March 5, 2026

**Re: Fisher Farm Wells #1-4 (PR# [16-2026](#))
City of Dayton (PWS ID# [00252](#))
Site Plan Approval**

Site Plan Approval – All 4 well locations approved

ATTACHMENT C.1
Fisher Farms Well 1 (YAMH 5370)
As-Built Well Diagram
 City of Dayton
 Initial OHA Plan Review

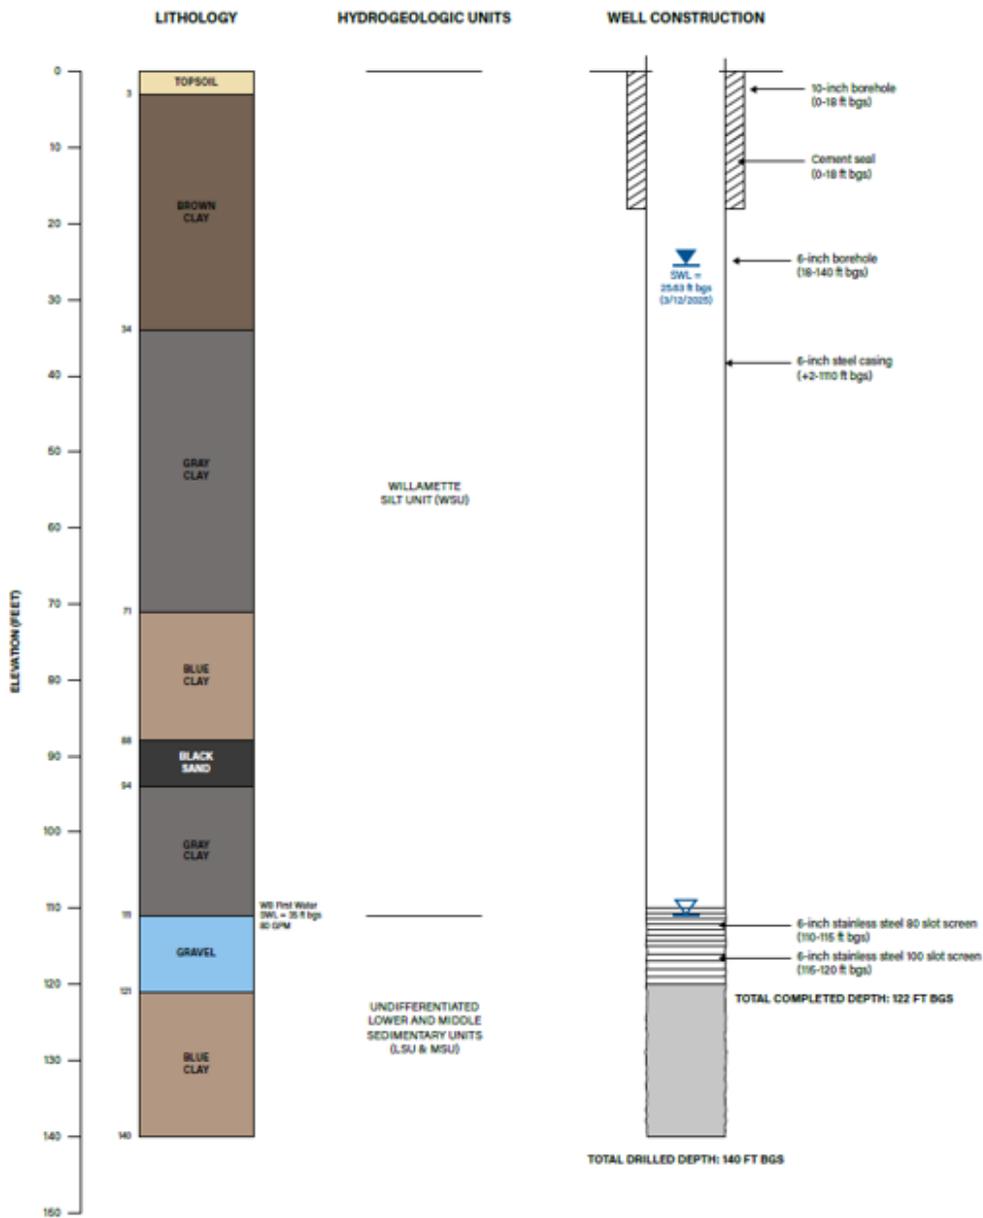
Comments: This well was drilled to a depth of 140 ft. The casing extends to a depth of 105 ft and is sealed to a depth of 18 ft below ground level. The casing seal is completed 15 ft into an 85 ft thick silt (clay) layer. A screen was place in the hole below the casing from 110 to 120 ft below ground. Water can enter the well below the casing and then through the well screen. Sensitivity Analysis results suggest that well construction is not highly sensitive to nearby land use practices.

Comments: This well draws water from a confined aquifer composed of sand and mixed sand and gravel. The first water-bearing zone below the casing seal was reported to occur at a depth of 88 ft and is overlain by 85 ft of low permeability silt (clay) that acts as a confining layer. Water in the aquifer is under pressure, rising 53 ft above the top of the first water-bearing zone to a depth of 35 ft below ground. Sensitivity Analysis results suggest that the aquifer is not highly sensitive to nearby land use practices.

Comments: A stormwater pond is within 360 ft of the wellhead. However, the GWUDI setback distance for sand is 75 ft and mixed sand and gravel is 100 ft. Since the stormwater pond is present at a greater distance than the GWUDI setback distances, there is no GWUDI concern with respect to this well.

ATTACHMENT C.2
Fisher Farms Well 2 (YAMH 5369)
As-Built Well Diagram
 City of Dayton
 Initial OHA Plan Review

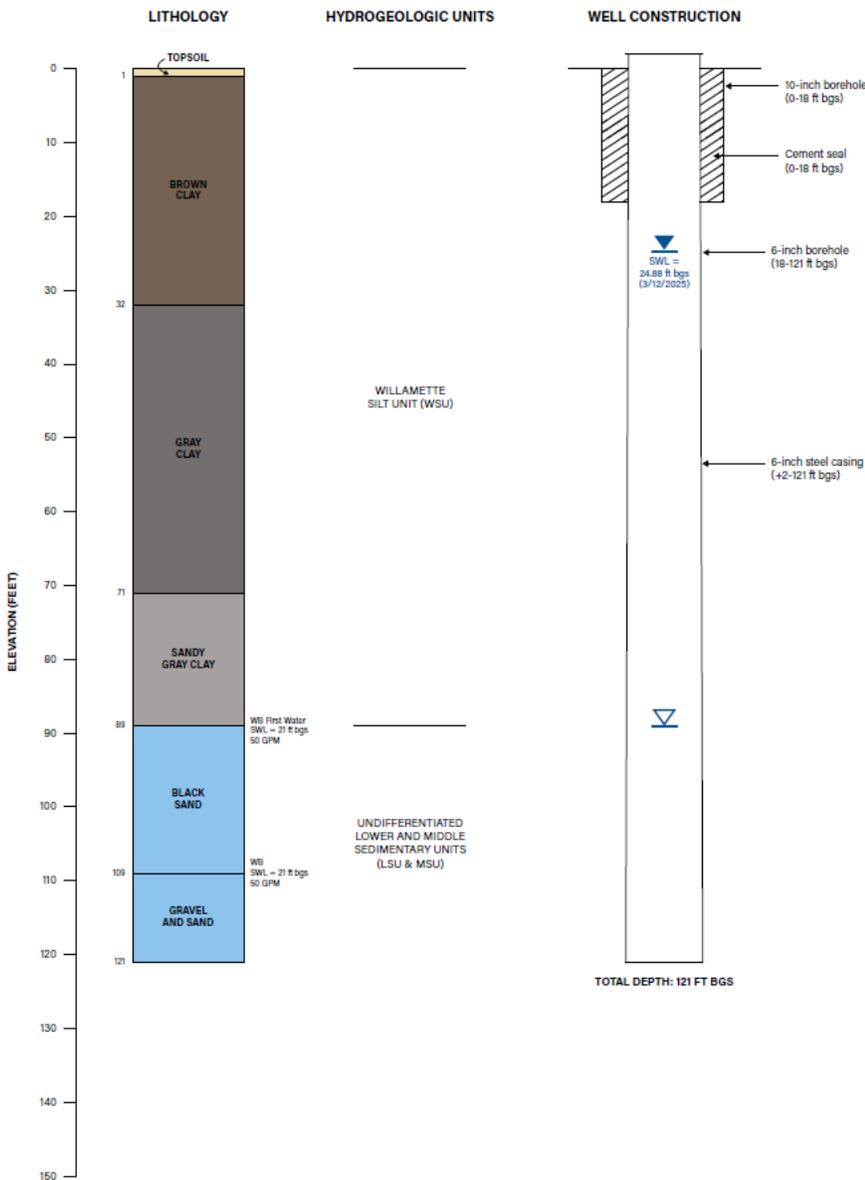
Comments: This well was drilled to a depth of 121 ft. The casing extends to the bottom of the hole and is sealed to a depth of 18 ft below ground level. The casing seal is completed 16 ft into an 87 ft thick silt (clay) layer. According to the water well report, the well is fully cased, there are no perforations in the casing or well screens present. Therefore, water can enter the well through the open end of the casing, 121 ft below ground level. Sensitivity Analysis results suggest that well construction is not highly sensitive to nearby land use practices.

Comments: This well draws water from a confined aquifer composed of sand and mixed sand and gravel. The first water-bearing zone below the casing seal was reported to occur at a depth of 89 ft and is overlain by 87 ft of low permeability silt (clay) that acts as a confining layer. Water in the aquifer is under pressure, rising 68 ft above the top of the first water-bearing zone to a depth of 21 ft below ground. Sensitivity Analysis results suggest that the aquifer is not highly sensitive to nearby land use practices.

Hydrogeologist comments regarding Waiver from Construction Standards Request: A septic drainfield associated with the house on the property is present within the 100-ft sanitary setback for this well. Rural septic drainfields are a source of fecal contamination. However, Sensitivity Analysis results suggest that the neither the well construction or the aquifer are highly sensitive to nearby land use practices. Therefore, this water source is not considered to be susceptible to fecal contamination from the septic drainfield.

Comments: A stormwater pond is within 345 ft of the wellhead. However, the GWUDI setback distance for sand is 75 ft and mixed sand and gravel is 100 ft. Since the stormwater pond is present at a greater distance than the GWUDI setback distances, there is no GWUDI concern with respect to this well.

ATTACHMENT C.3
Fisher Farms Well 3 (YAMH 52469)
As-Built Well Diagram
 City of Dayton
 Initial OHA Plan Review

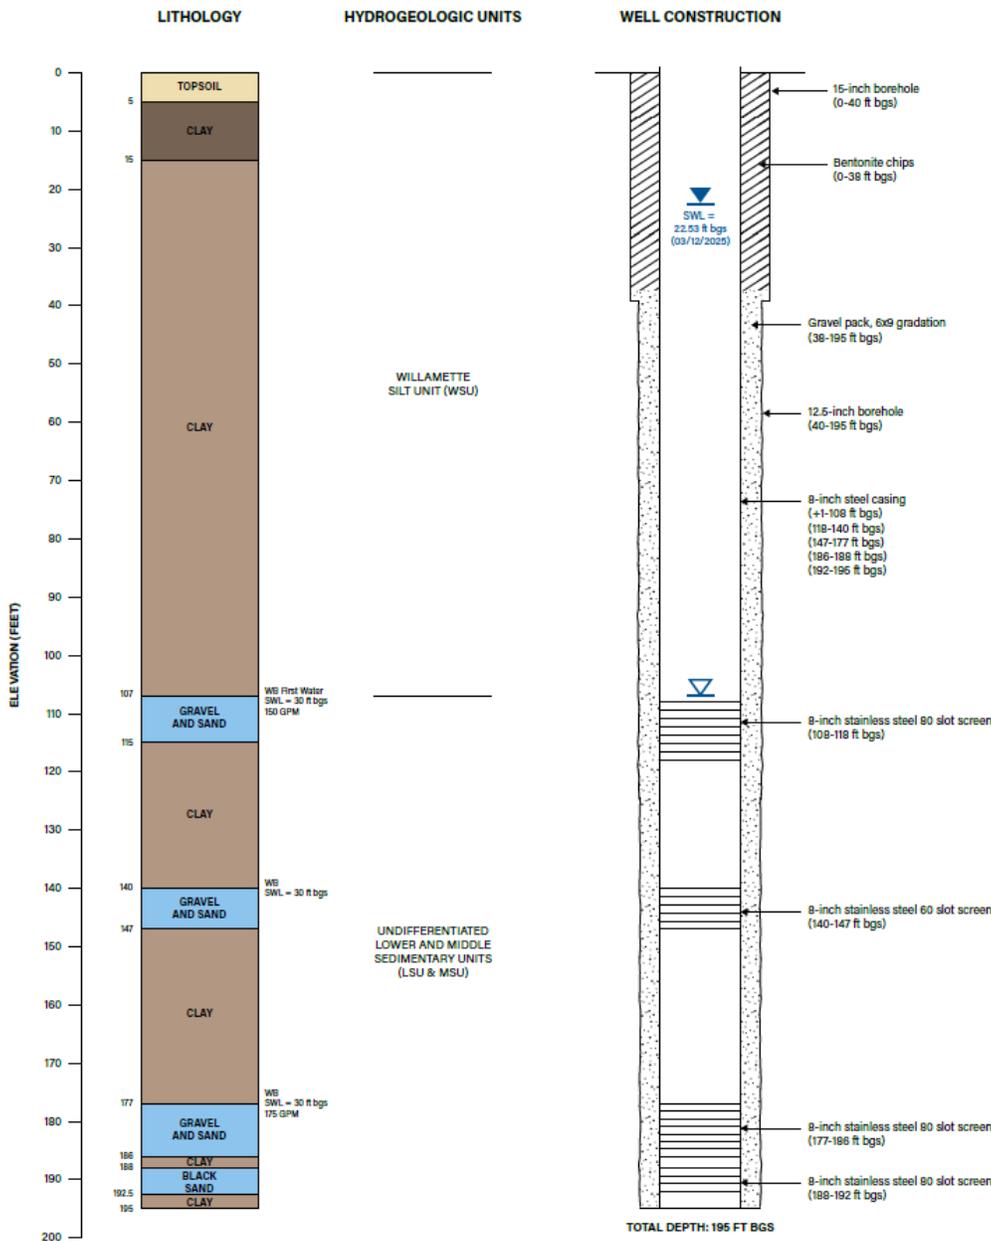
Comments: This well was drilled to a depth of 195 ft. The casing extends to the bottom of the hole and is sealed to a depth of 38 ft below ground level. The casing seal is completed 33 ft into a 102 ft thick silt (clay) layer. According to the water well report, the casing is perforated at various intervals beginning at 108 ft below ground and extending to the bottom of the casing. Outside the casing, the well is gravel-packed from a depth of 38 ft to the bottom of the hole. Therefore, water enters the well by traveling through the gravel pack below the casing seal and then through the perforations. Sensitivity Analysis results suggest that well construction is not highly sensitive to nearby land use practices.

Comments: This well draws water from a confined aquifer composed of sand and mixed sand and gravel. The first water-bearing zone below the casing seal was reported to occur at a depth of 107 ft and is overlain by 102 ft of low permeability silt (clay) that acts as a confining layer. Water in the aquifer is under pressure, rising 77 ft above the top of the first water-bearing zone to a depth of 30 ft below ground. Sensitivity Analysis results suggest that the aquifer is not highly sensitive to nearby land use practices.

Hydrogeologist comments regarding Waiver from Construction Standards Request: An agricultural field is present within the 100-ft sanitary setback for this well. Irrigated crops are considered to be a moderate-risk to groundwater. However, Sensitivity Analysis results suggest that the neither the well construction or the aquifer are highly sensitive to nearby land use practices. Therefore, this water source is not considered to be highly susceptible to activities associated with this land use practice within the sanitary setback.

Comments: A stormwater pond is within 210 ft of the wellhead. However, the GWUDI setback distance for sand is 75 ft and mixed sand and gravel is 100 ft. Since the stormwater pond is present at a greater distance than the GWUDI setback distances, there is no GWUDI concern with respect to this well.
